Product Bulletin # CDS-008

Nov. 19, 2021

# **ICDS Grapple Retention Retrofit Solution**

Figure 4

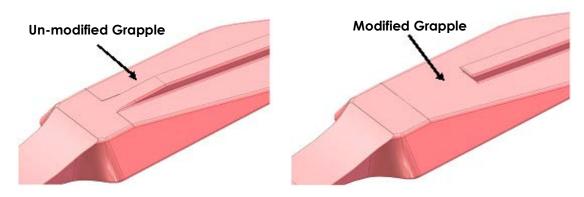
- Machine the slots, drill and thread the holes as per P/N: 5101754 Mandrel, 13-3/8" Modified for grapple retention.
- Refer to Appendix A for drawing 5101754.
- 3. Modification of 'on hand' Grapples (all grapple sizes 12-3/4" to 16-3/4") qty. 5 per set See Figure 4.

- If it is determined that the grapples are still serviceable, modify the grapples' rib as per P/N: 5101755 Grapple, 12-3/4" to 16-3/4", Modified for retention.
- Refer to Appendix B for drawing 5101755.

### Grapple Retention Kit, 17-7/8" to 20" Grapples - Canrig P/N: 5101745

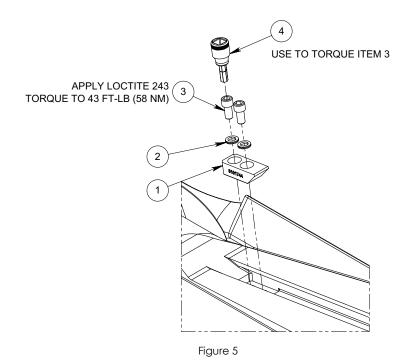
- 4. Grapple Retainers Procurement
  - a. Procure P/N: 5101757 Kit, Grapple retention, 12-3/4" to 16-3/4" grapples from RIGLINE 24/7<sup>TM</sup>.

- \* Include 2 spares each
  - Refer to Appendix C for #5101757 Grapple Retention Kit drawing.

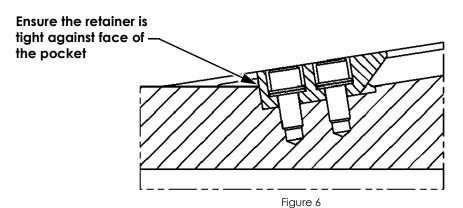
- 5. Assemble P/N: 5101744 Grapple Retainers (qty. 5) on the modified mandrel.
  - Refer to Figure 6 for the assembling detail.
  - Apply Loctite #243 to the screws.
  - Ensure the correct orientation of the Grapple Retainer.
  - Ensure the proper installation of the Nord-Lock washers.
  - Ensure the retainer is tight to the face of the pocket before the bolts are tighten. See Figure 6:

- Use P/N: 50101759 Allen Bit Socket and appropriate Torque Wrench to tighten the screws to 43 ft-lb.
- 6. Re-assemble the Drive with modified mandrel to the actuator.
  - Refer to the CDS Maintenance Guide Document # 883004 for instructions on how to re-install the mandrel and other Drive components to the Actuator.
- 7. Install modified Grapples.
  - Refer to the CDS Installation and Operations Guide Document # 883003 for instructions on how to install the grapples.

Figure 7

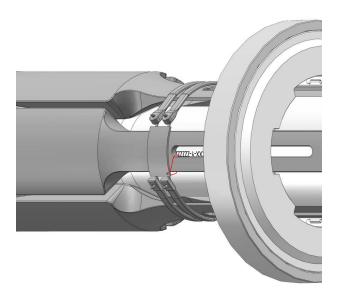
**Note:** The P/N: 5102566 – Grapple Retaining Strap – (see Figure 7), is required for retrofitted 12-3/4" to 16-3/4" ICDS tools.
